SONOCUR

Service Instructions SP010/02/I

Title: Fuse F5 of the cooling unit

Fig. 1

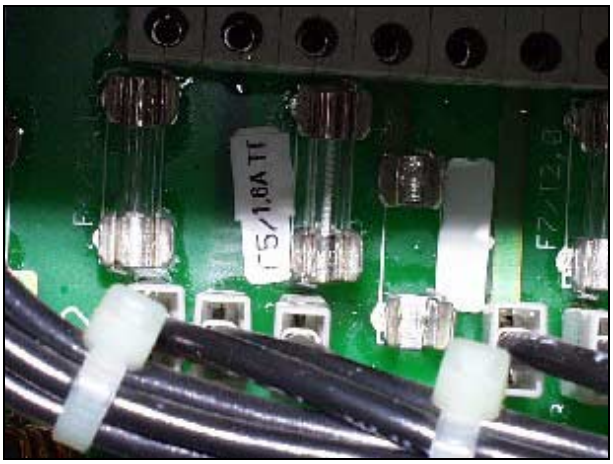
Depending on the line voltage or the line frequency it can happen that the fuse F5 of the cooling unit on board D1 responds when the system is switched on.

- Switch the system off and pull out power plug.
- Remove the covers.
- Remove defective fuse from board D1.
- Cover the fuse value printed on the board with a new label.
- Insert new 1.6A FTT fuse.
- Reattach covers.
